ADDENDUM 3

November 30, 2018

WET WEATHER COMBINED SEWER STORAGE – PHASE 1

CONTRACT NO. W-17-004-101

SHEET **M300**

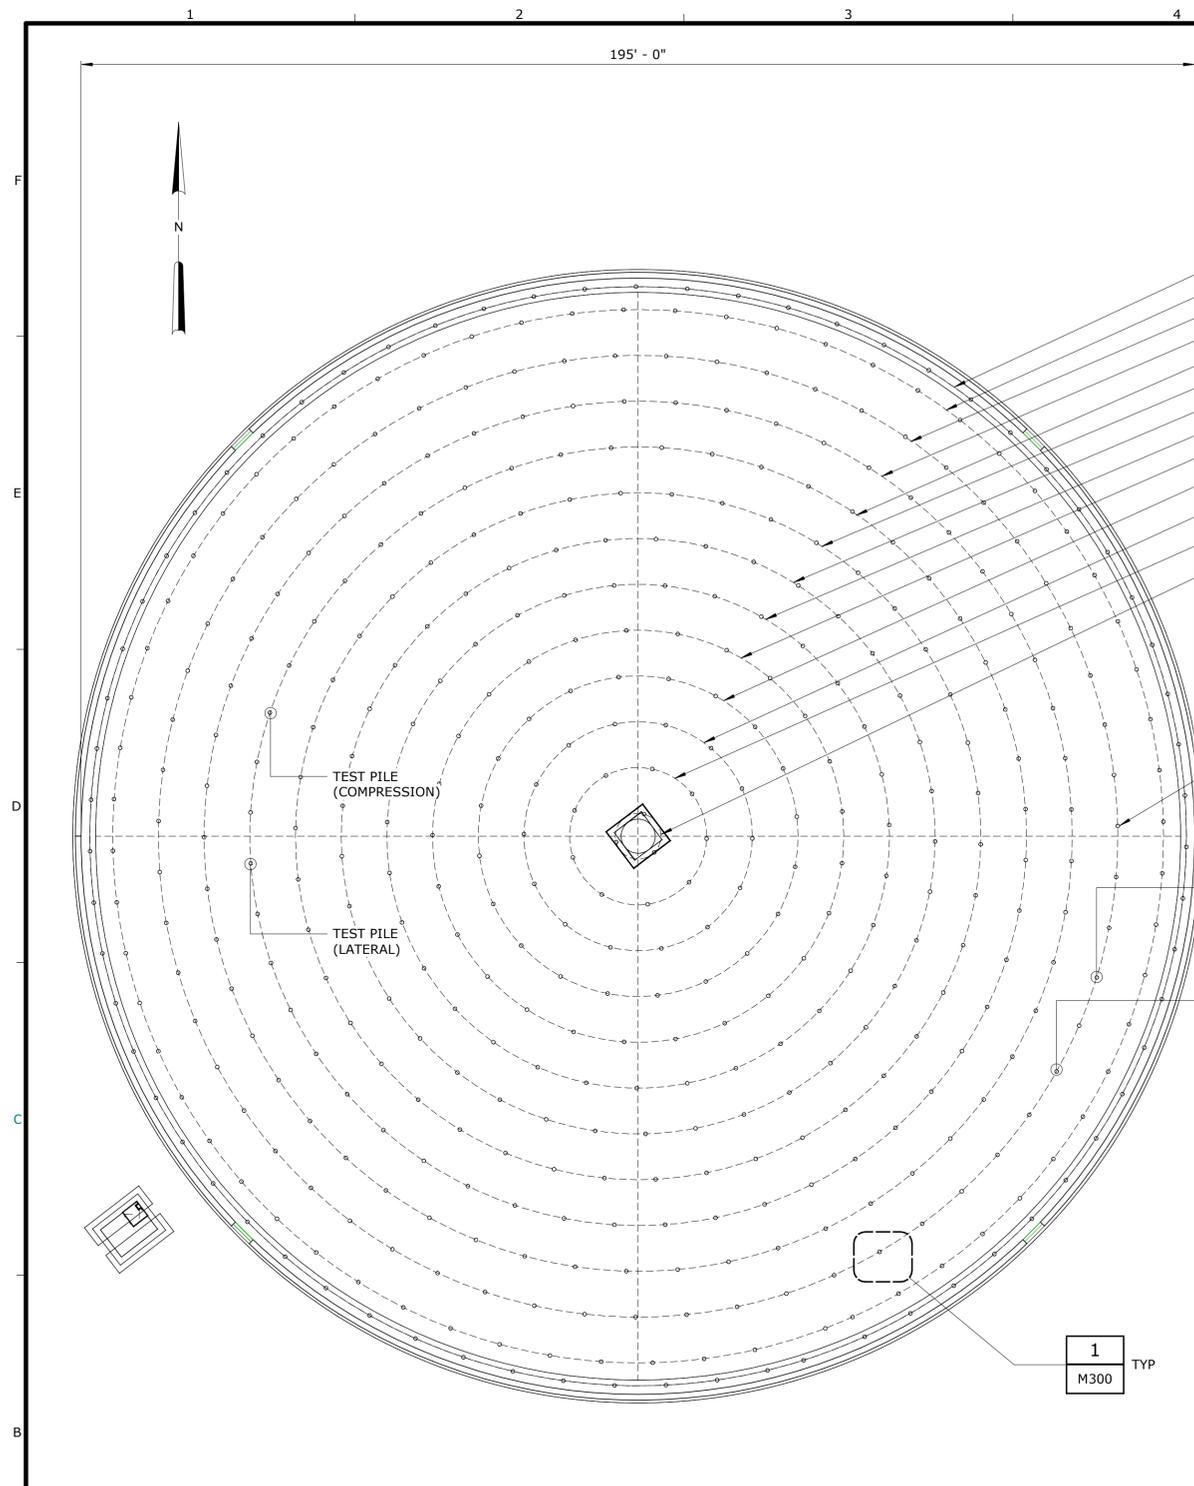
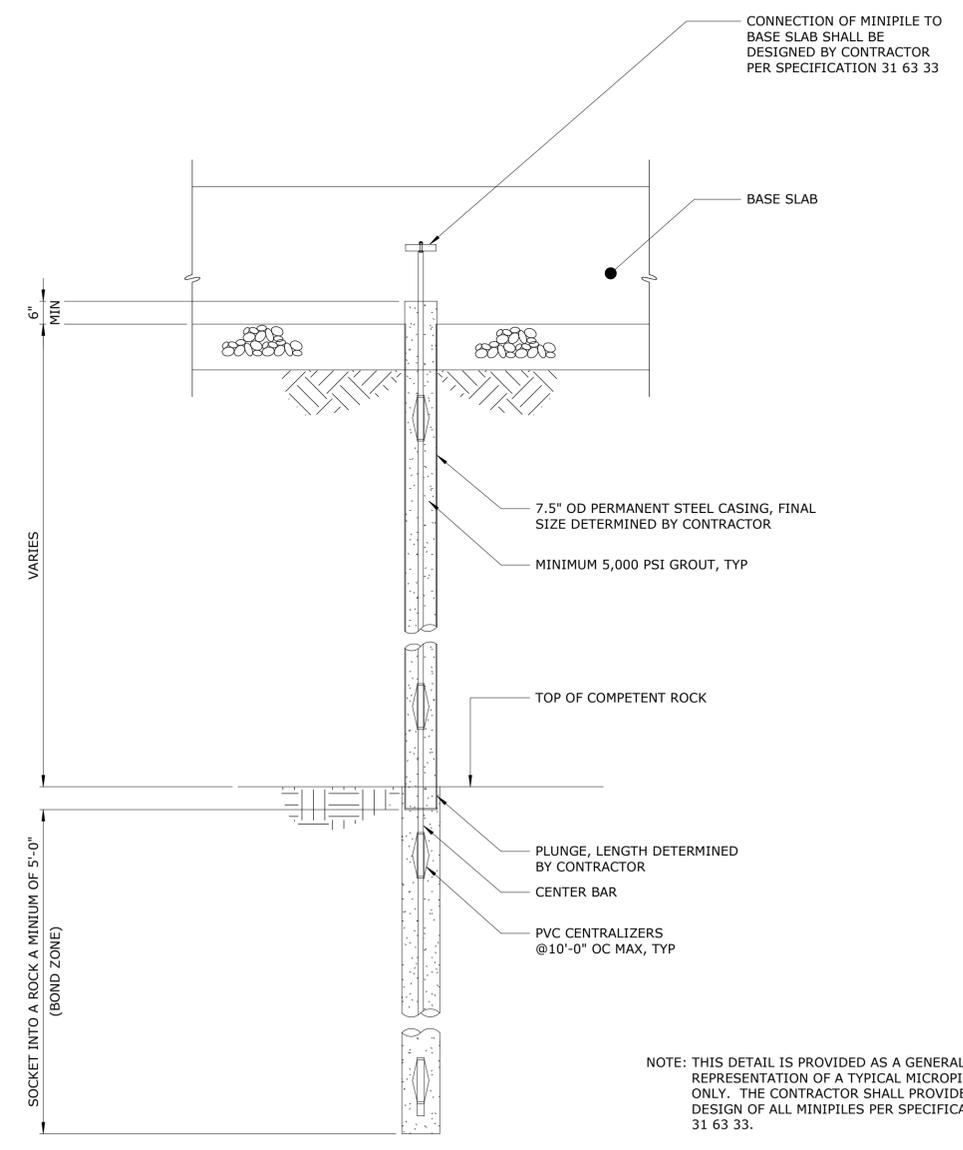
Answer: Refer to Additional Information item b above for reference to Wage Determinations.
4. **Question:** Sheet M300 includes a micropile schedule for Tanks 1, 2, and 3. For Tanks 2 and 3, the “Estimated pile length to top of rock (ft) is shown to be 51.75 feet, and the “Estimated total length of pile group to top of rock (ft) is shown to be 24,426 feet for each tank.

The “Top of pile elevation (max)” is shown to be 666.75 and the “Estimated top of rock elevation is shown to be 620.00, which would make the “Estimated Pile length to top of rock” 46.75 feet for each pile, and the “Estimated total length of pile group to top of rock” 22,066 LF for each Tank.

Please Clarify the correct information for the micropiles.

Additionally, it appears the footage of micropile in the rock socket is not included in the estimated quantities shown in the bid form. Is this correct? Is this how the measurement for payment purposes will be handled?

Answer: Refer to the revised M300 sheet and Bid Form (attached) with updated quantities. The cost for the length of the plunge and rock socket shall be incorporated into the vertical foot unit cost of micropile from the structure to top of rock. There will be no separate payment for plunge or rock socket length.

TANK NO.	TOP OF PILE ELEVATION		ESTIMATED TOP OF ROCK ELEVATION	ESTIMATED PILE LENGTH TO TOP OF ROCK (FT)	QUANTITY OF PILES IN GROUP	ESTIMATED TOTAL LENGTH OF PILE GROUP TO TOP OF ROCK (FT)
	MAX	MIN				
1	666.75	664.42	610.00	56.75	472	26786
2	666.75	664.42	620.00	46.75	472	22066
3	666.75	664.42	620.00	46.75	472	22066
